# Certificate of Appropriateness

| <b>Property</b>            | 2617 N. Grant Blvd.   | Grant Boulevard          |
| <b>Description of work</b> | Construct wood fence where indicated on site plan per attached design. Fence will be a combination of board and lattice construction and vertical board construction where indicated. |                          |
| <b>Date issued</b>         | 6/12/2019   | PTS ID 114781 COA: fence |

Diagram indicating the location and typology of fence

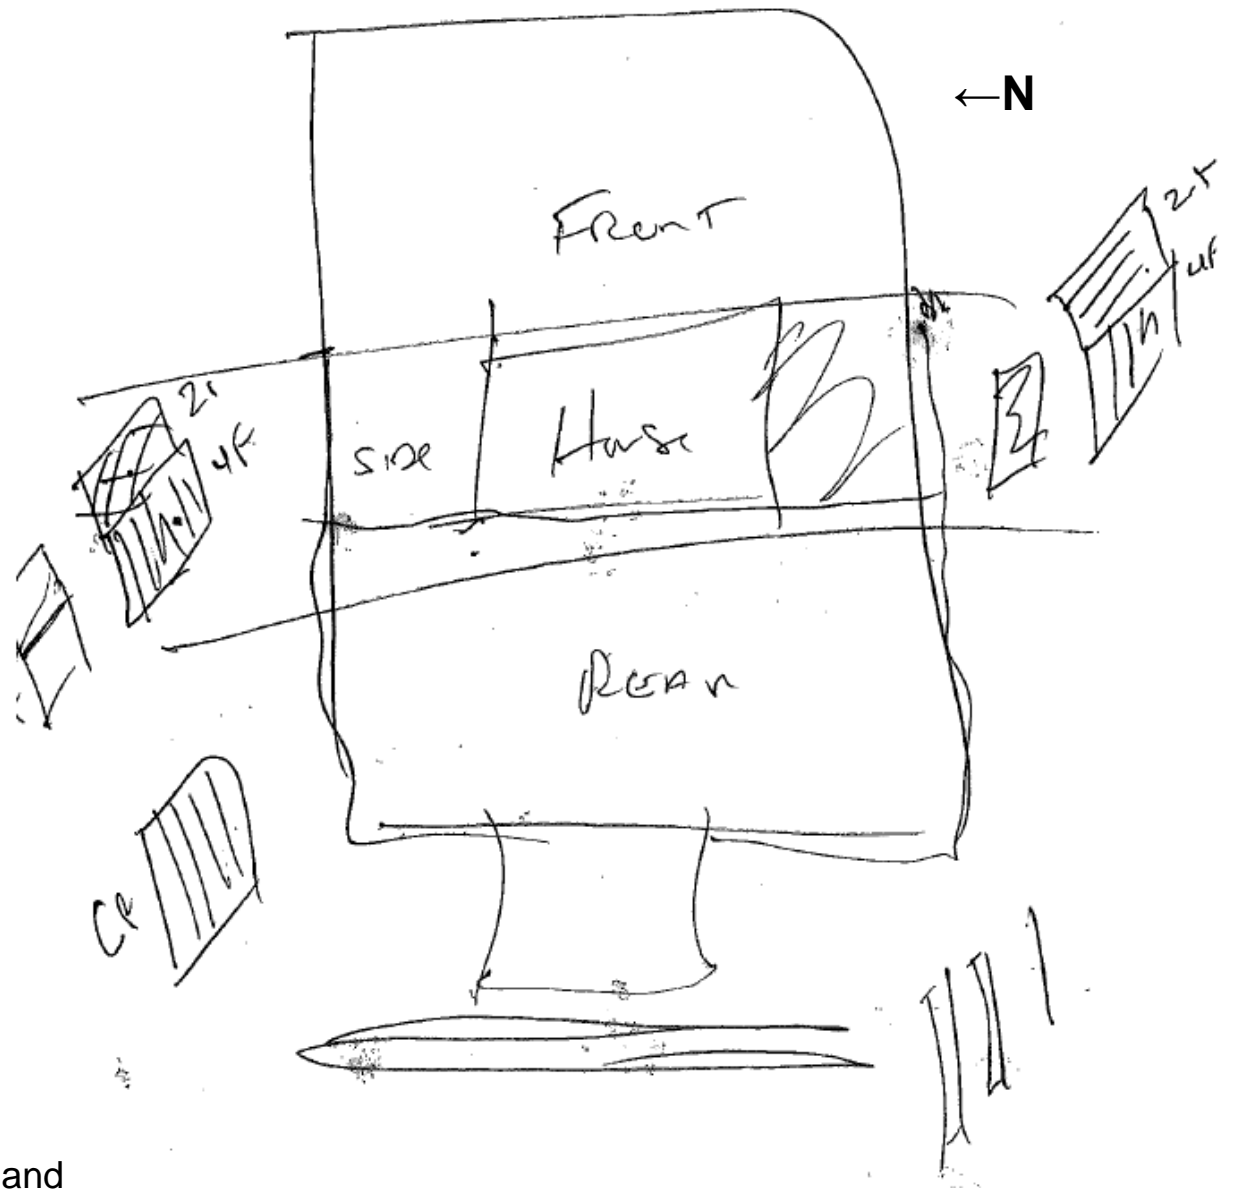
Fence will be board and lattice at the north and south ends (sides) of the property and dog ear vertical board at the west (rear) of the property. Posts may be less decorative than indicated, but must have some degree of cap feature.

All wood must be smooth and equivalent to #1 grade cedar or better for use in rear and side yards. Sections of fence forward of or in line with the primary building's front setback must be clear grain. Wood fences must be painted or stained with an opaque stain upon completion. Note: when new, bare wood is left exposed to the exterior elements for a period of only a week or two, the life of the paint job subsequently applied to it will be decreased.
